Scott Horsley
Water Resources Consultant
65 Little Road • Cotuit, MA 02635 • 508-364-7818

RE: Thorndike Place

Figure 2 - Hydrograph for USGS Lexington Index Well (March - April 2024)

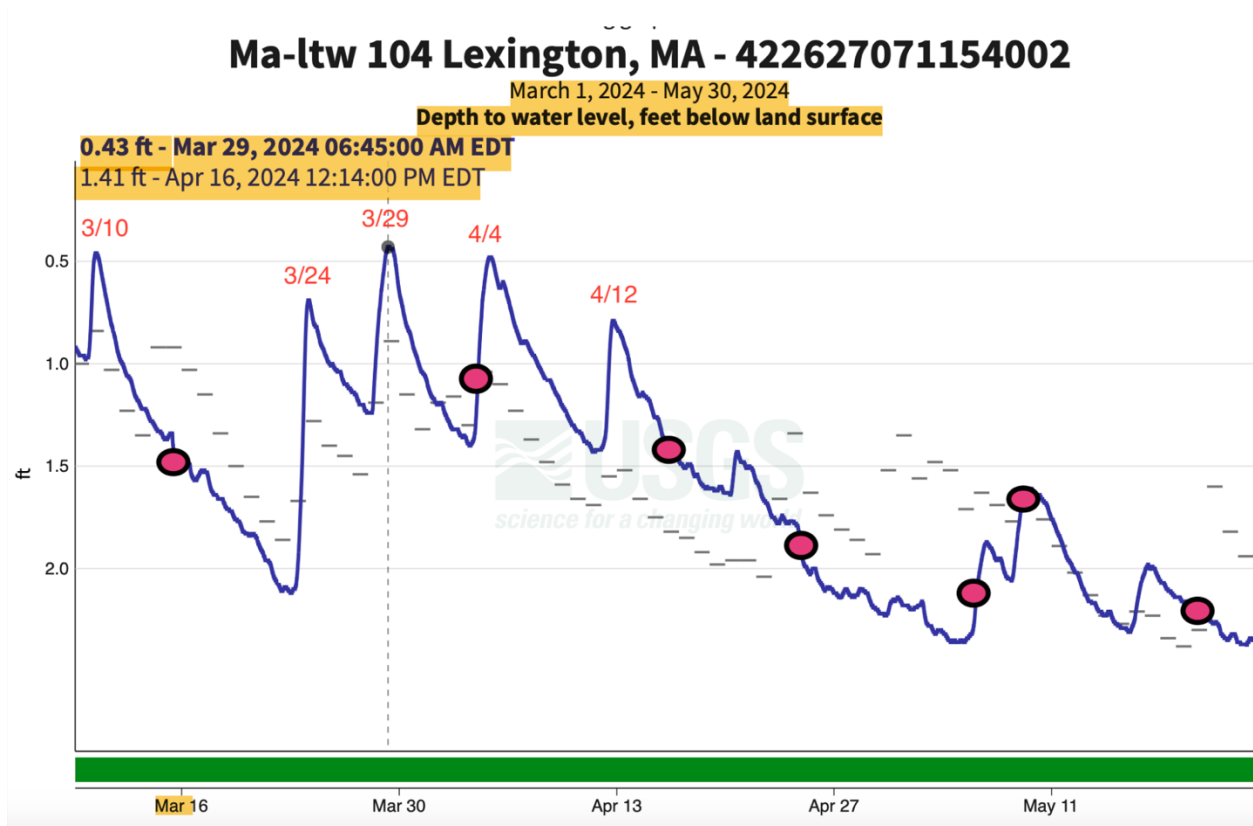
Figure 2 shows a comparison of water levels measured in a well installed by BSC at the location of TP-9 (red dots) with the USGS Lexington well hydrograph during the 2024 spring period. This comparison shows that BSC water level measurements were reported on dates that missed all of the peak levels recorded at the USGS well during the Spring 2024 period. The highest groundwater levels were observed at the USGS well on March 24, 29, and April 4. Had BSC used a continuous recorder (as I recommended in my earlier comment letters) they would have likely recorded higher levels, consistent with the USGS well).

This comparison shows that the highest water level measured by BSC was on April 1 when the USGS well was more than one foot below its peak high measurement on March 10. This suggests that the ESHGW would be at least 5.0 feet. This would be consistent with the redox level of 5.8 feet reported by Whitestone.

- the applicant underestimates seasonal high groundwater conditions and a value of 5.0 – 5.8 feet should be utilized rather than 4.0 feet. This provides a more realistic and conservative value.
- a groundwater mounding analysis is required and should be evaluated for the revise infiltration system #1. This has not been provided by the applicant.

Figure 3 - Hydrograph for Arlington Land Trust (ALT) Monitoring Wells at Dorothy Road (March - April 2024)

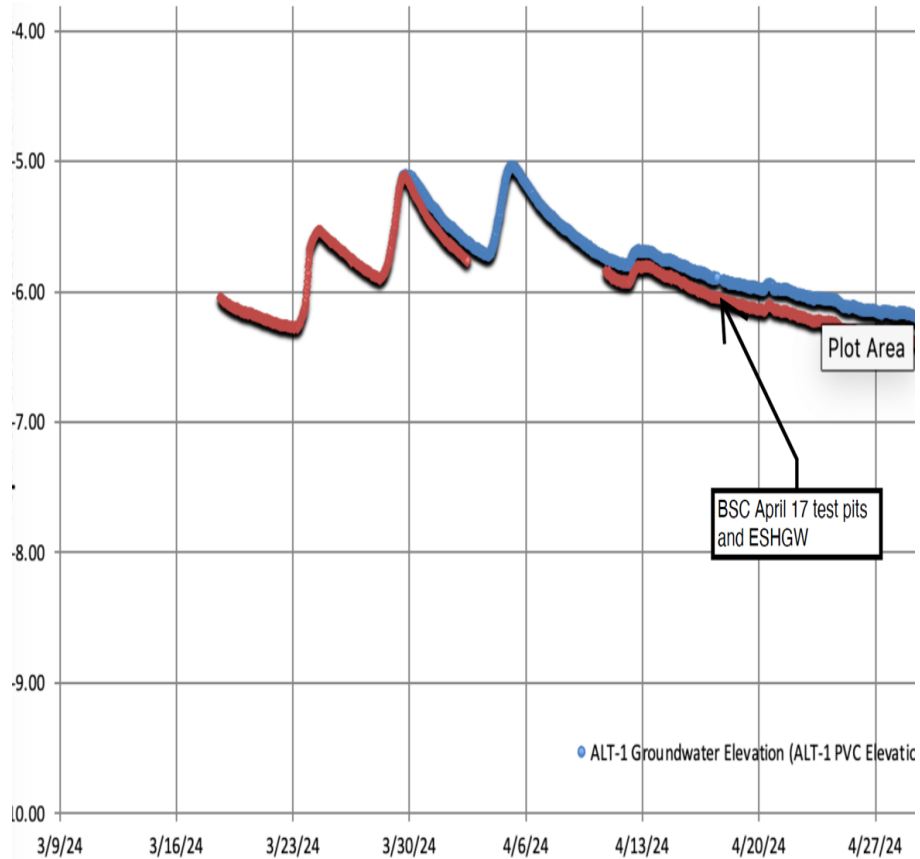
This same variance in groundwater levels is further corroborated with our own water level measurements at the Arlington Land Trust well located on Dorothy Road which showed a peak elevation on March 29, 2024 and a similar decline throughout much of April to a level of approximately 1-foot lower on April 17 when the test pits were excavated (see figure 3). This suggests that the relative groundwater level fluctuations over this period are consistent with the USGS Lexington well (which showed a 1-foot decline during this same period).
